DIVISION OF PURCHASES BID NO. 7598779

BRIDGE GROUP 58A – DIVISION STREET

NOTICE TO PROSPECTIVE BIDDERS

ADDENDUM NO. 6      Prospective bidders and all concerned are hereby notified of the following changes in the Plans, Specifications, Proposal and Distribution of Quantities for this contract. These changes shall be incorporated in the Plans, Specifications, Proposal and Distribution of Quantities, and shall become an integral part of the Contract Documents.

TYPICAL SECTION 1 AND JOB  
SPECIFIC LEGEND  
SHEET 1 OF 3

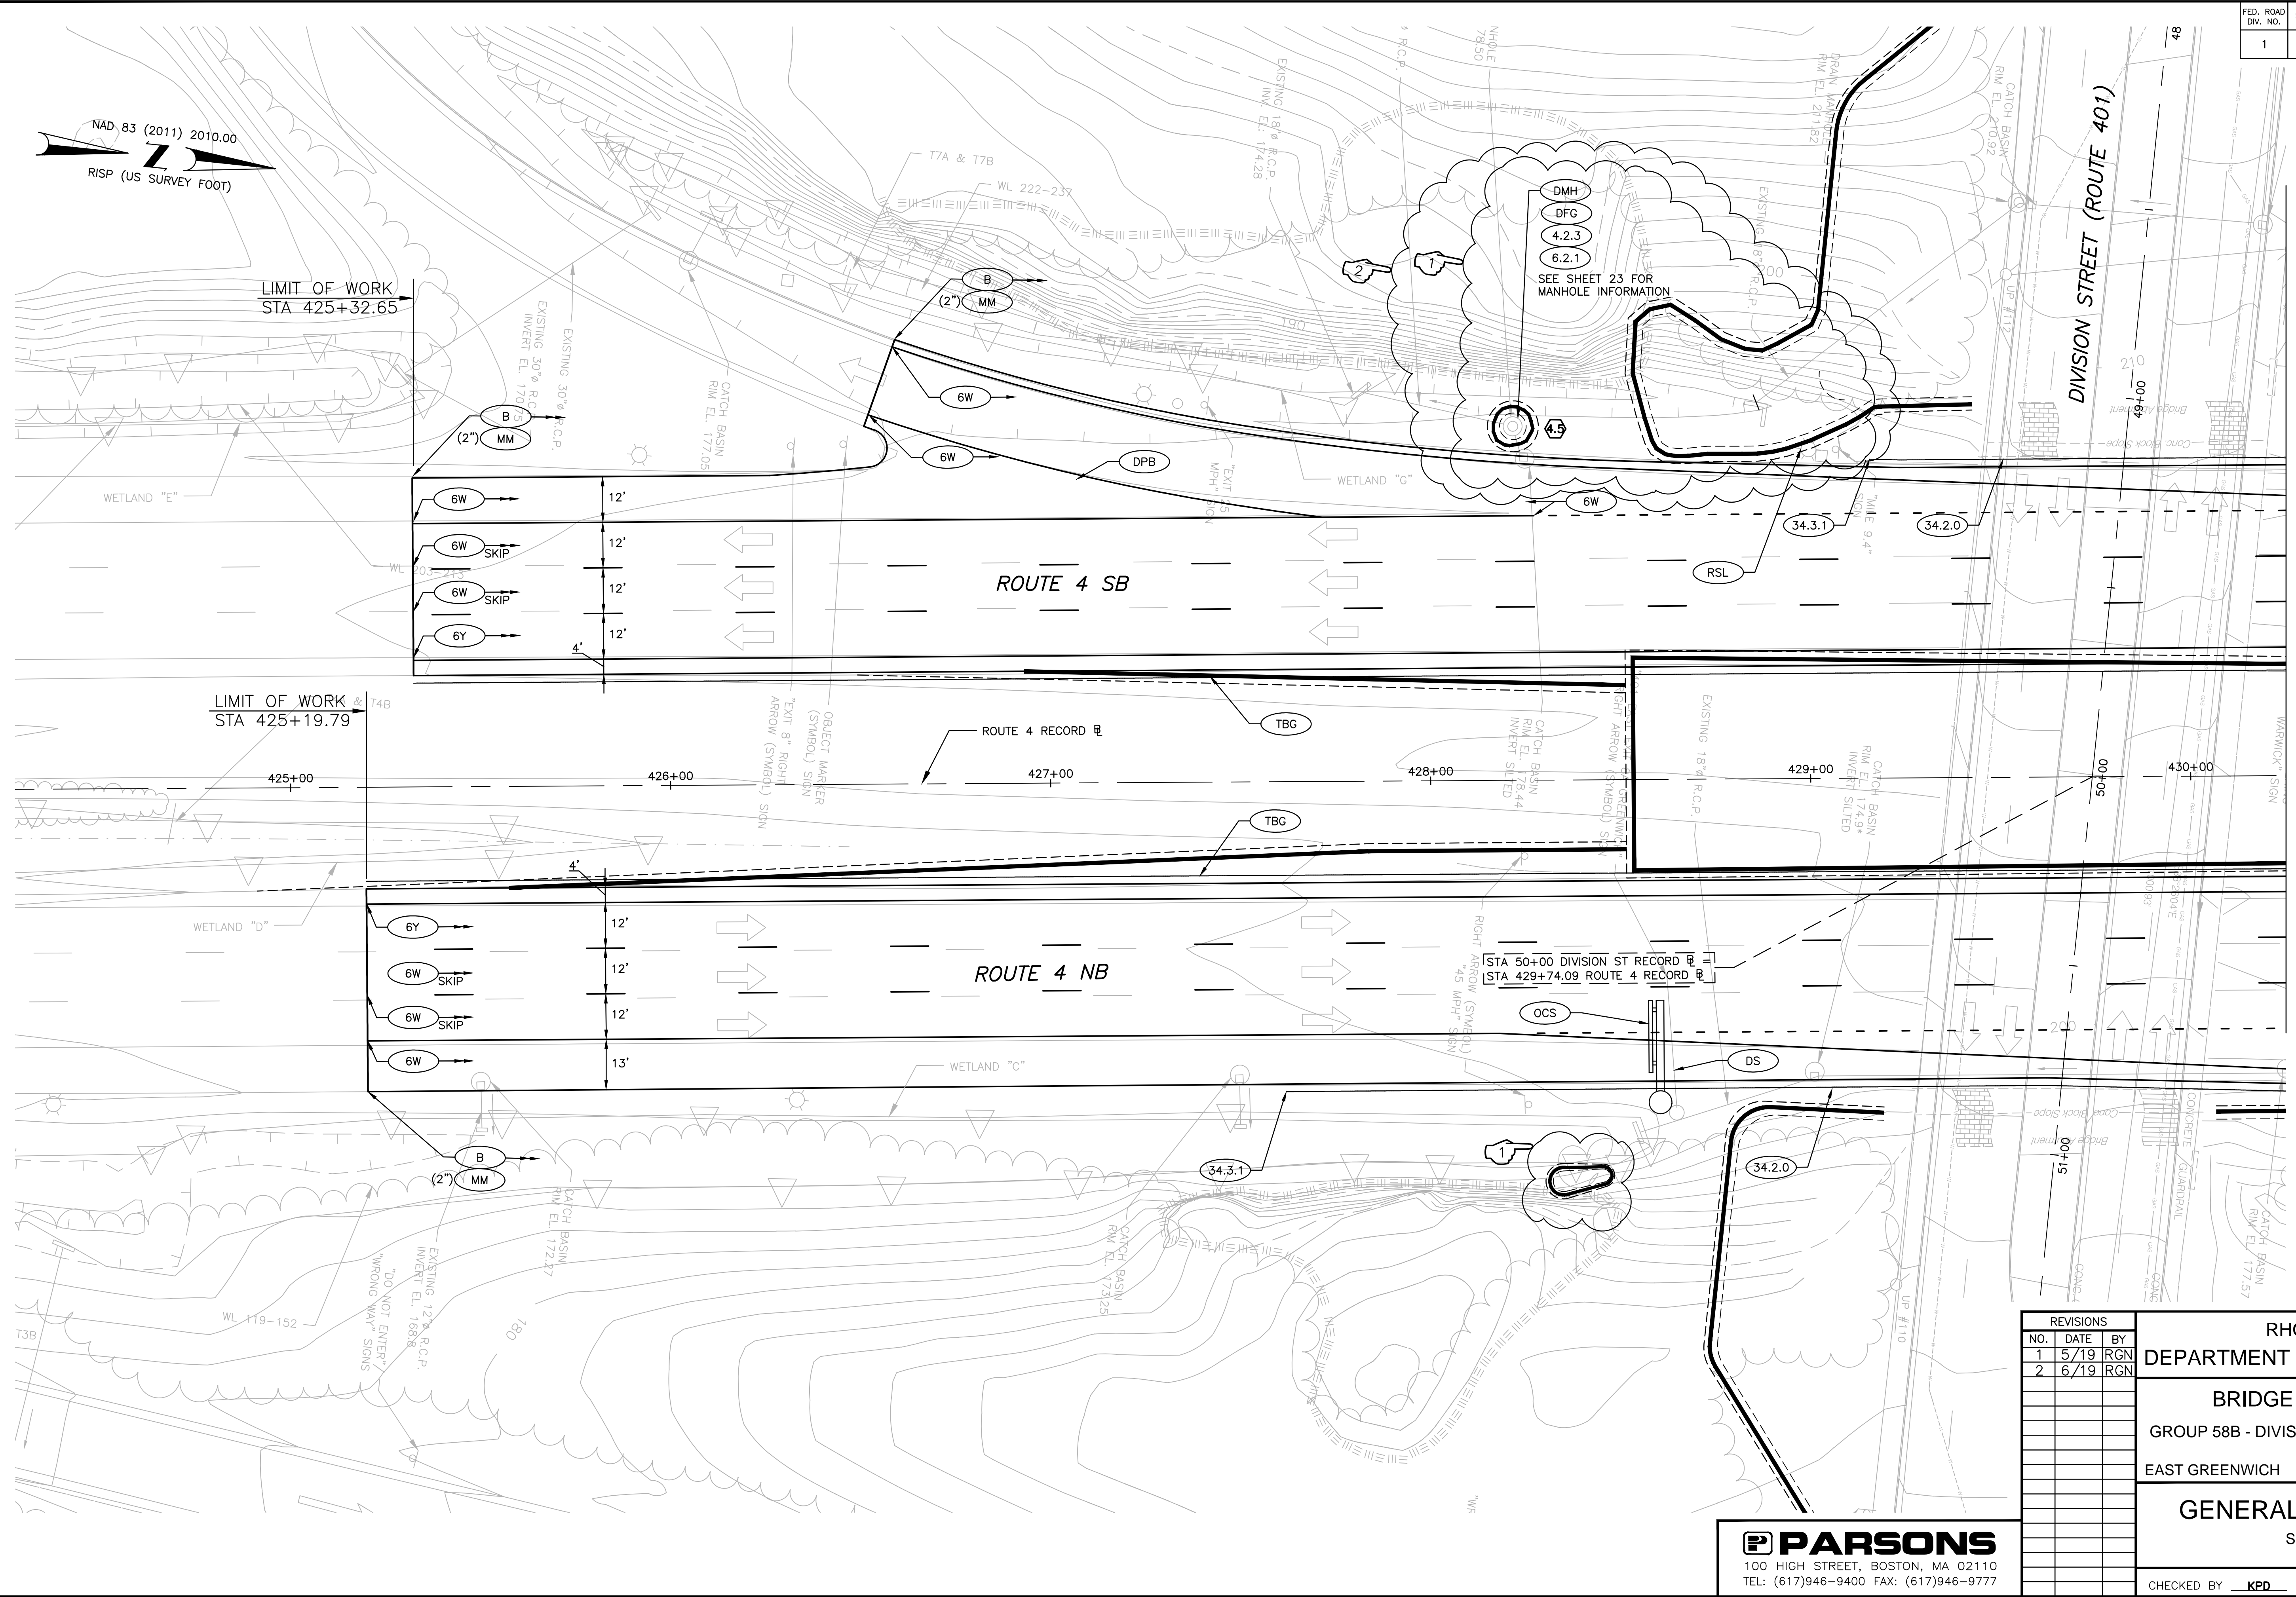
The distribution of quantities and pay item 005 - 201.0401 Remove and Dispose Granite Curb appears to be SGC-Stockpile Granite Curb per General Plans. Please Clarify

A new symbol will be added to the plans for DCG: Remove and Dispose Granite Curb. Plans will be updated via Addendum.

REVISIONS				RHODE ISLAND DEPARTMENT OF TRANSPORTATION	
NO.	DATE	BY	REASON		
1	6/19	RGN		BRIDGE REPLACEMENT GROUP 58B - DIVISION STREET BRIDGE NO. 760	
				EAST GREENWICH RHODE ISLAND	
				BEARING DETAILS (SHEET 2 OF 2)	
CHECKED BY				DATE	SCALE
				AS NOTED

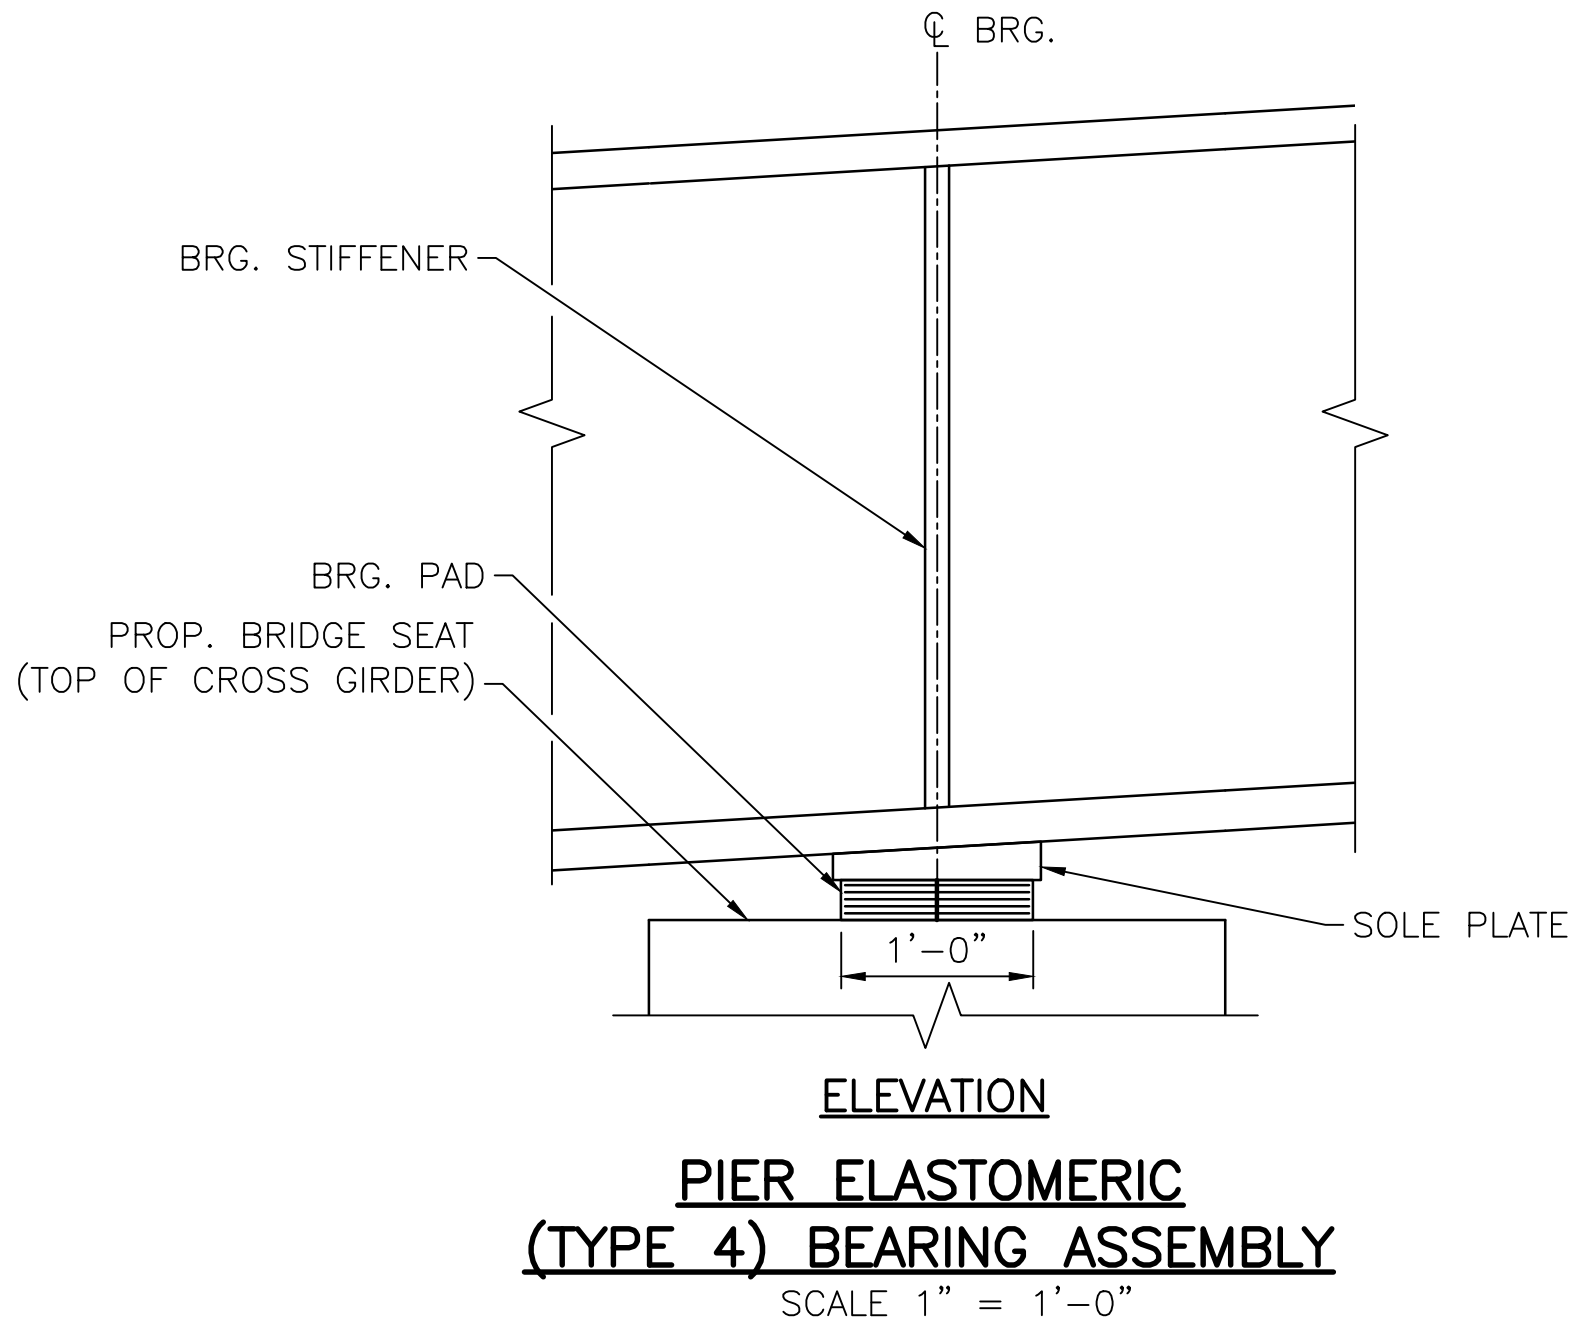
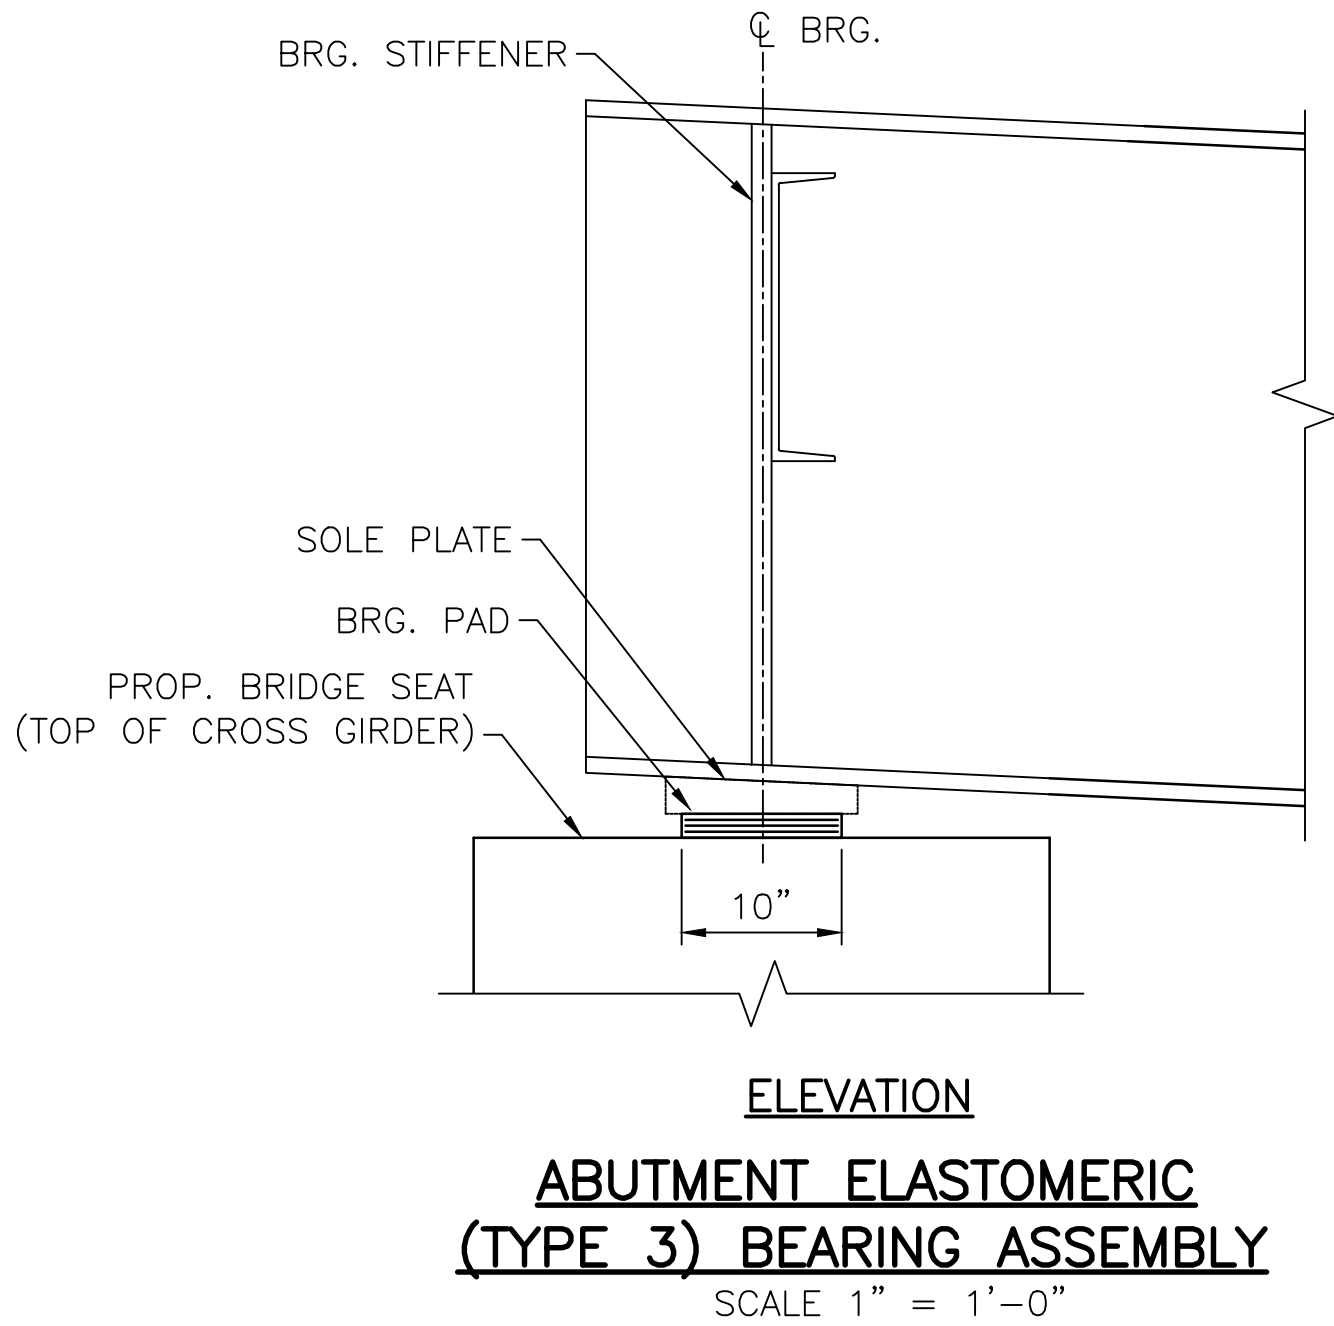
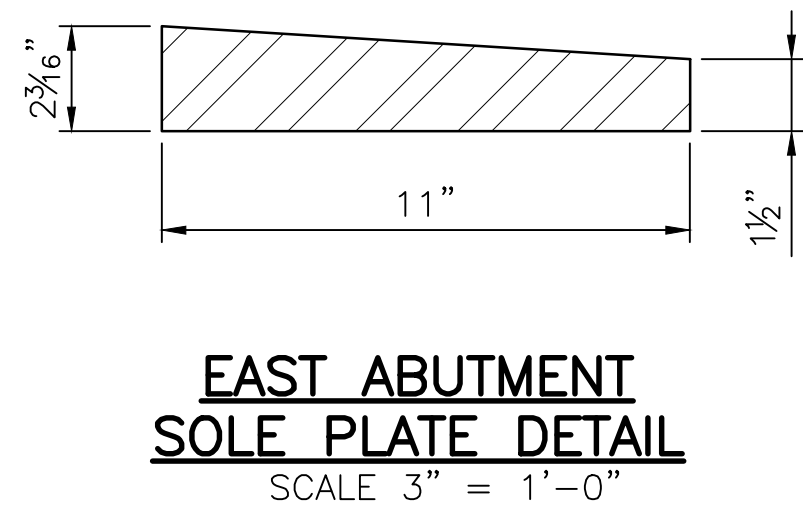
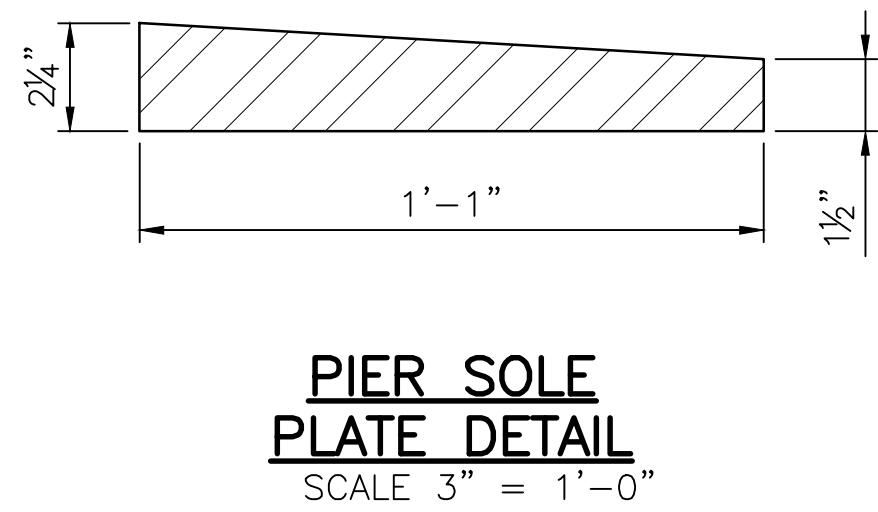
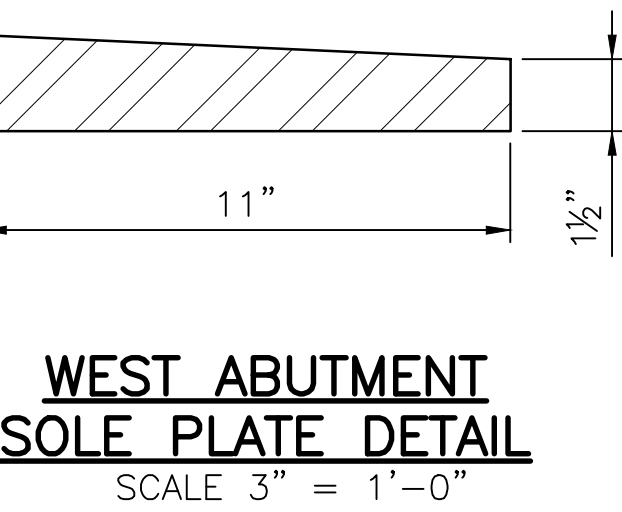
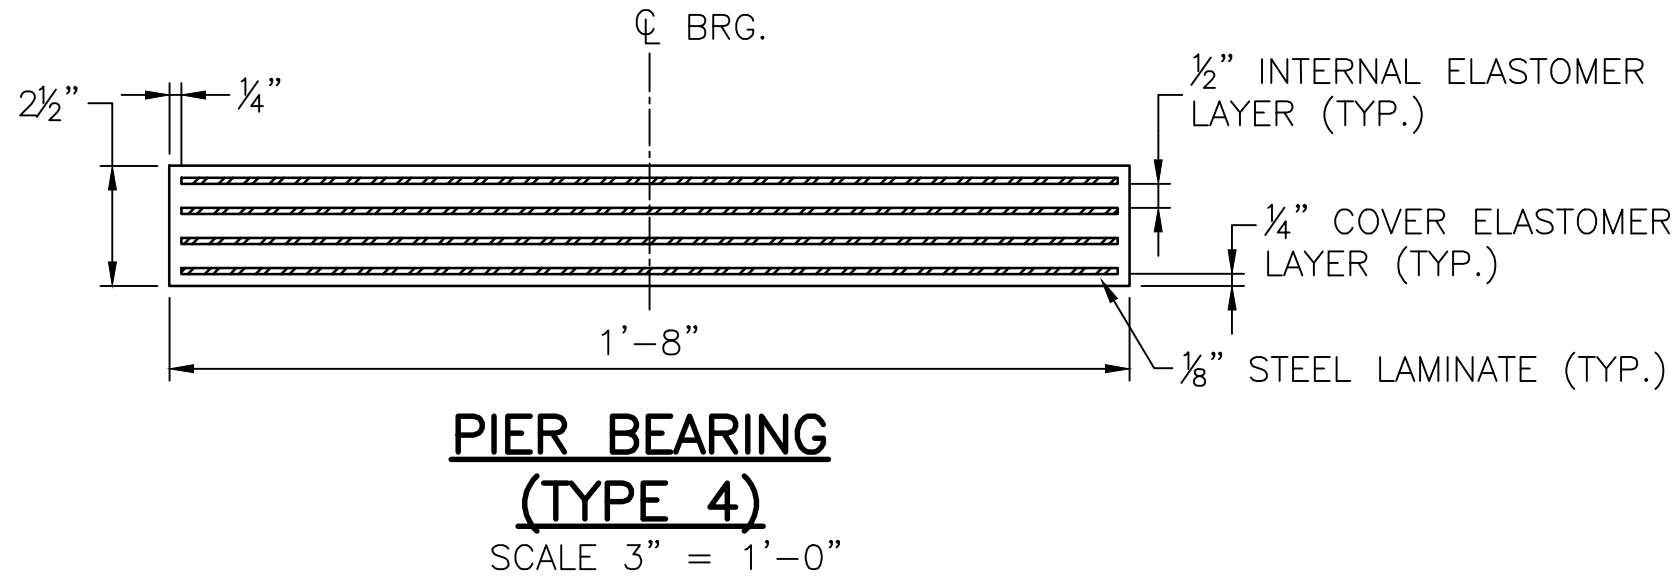
On Bearing Details Sheet 2 of 2 (Sheet No. 121 of 134), in Sections RR & SS the welding symbol indicates that the Sole Plates are to be Shop Welded to the Stringer Bottom Flanges whereas Note No.'s 9 & 10 seem to indicate that the Sole Plates are to be Field Welded? Please provide clarification.

Sole Plates will be field welded. Sheet 121 will be updated via Addendum.
